City of Detroit  
Inter-Departmental Communication

**RE:** Petition No. 146  
Request to Outright Vacate Certain Easements and Public Right of Ways in The  
Area of 1404-1458 Vermont In the Area Bound by Bagley, Rosa Parks, Porter,  
and Vermont

REQUEST TO VACATE CERTAIN  
 EASEMENTS AND PUBLIC RIGHT OF WAYS  
 IN THE AREA OF 1404-1458 VERMONT ST.  
 IN THE BLOCK BOUND BY  
 BAGLEY AVE., ROSA PARKS BLVD., PORTER ST.  
 AND VERMONT AVE.

CITY OF DETROIT CITY ENGINEERING DEPARTMENT SURVEY BUREAU	
JOB NO.	01-01
DRWG. NO.	X 146

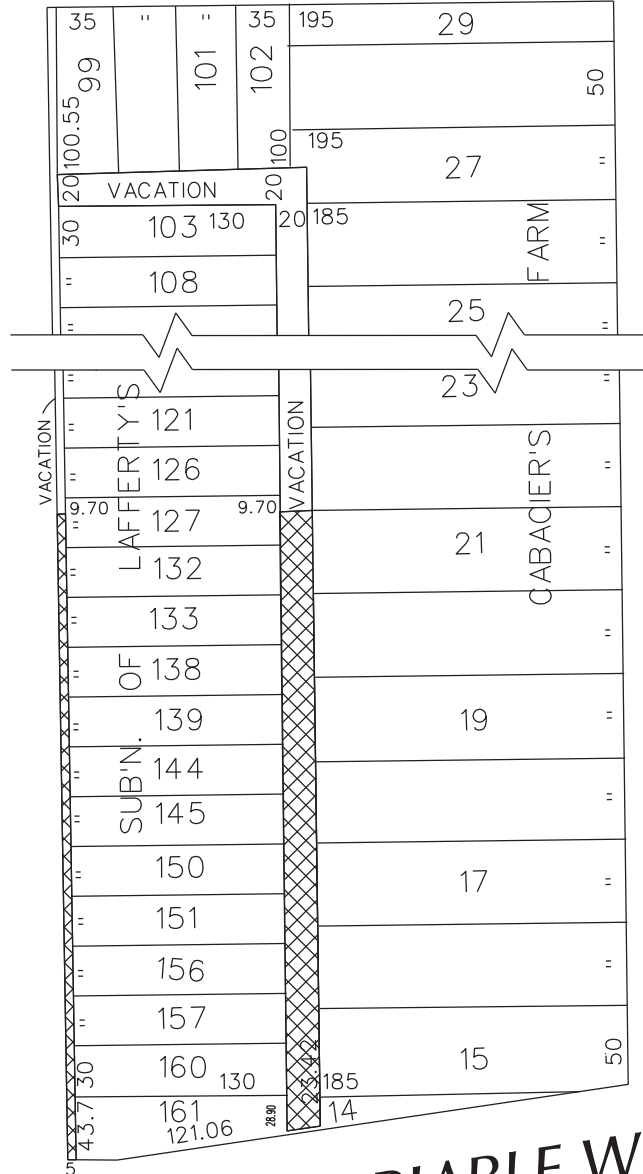
- Our records indicate that there is a sewer in the alley. DWSD objects to the outright vacation. However, DWSD has no objections if the petitioner agrees to relocate the sewer in accordance with the attached Provisions for relocation at no cost to DWSD.

Provided that the petitioner (Petition No.146) shall design and construct proposed lateral sewer and make the connections to the existing public sewers as required by the Detroit Water and Sewerage Department (DWSD) prior to construction of the proposed sewers

Provided, that the petitioner shall grant to the City a satisfactory easement for the lateral sewers; and further

Provided that upon satisfactory completion the lateral sewers shall become city property, and part of the City system. And any existing sewers that were abandoned shall belong to the petitioner and will no longer be the responsibility of the City.
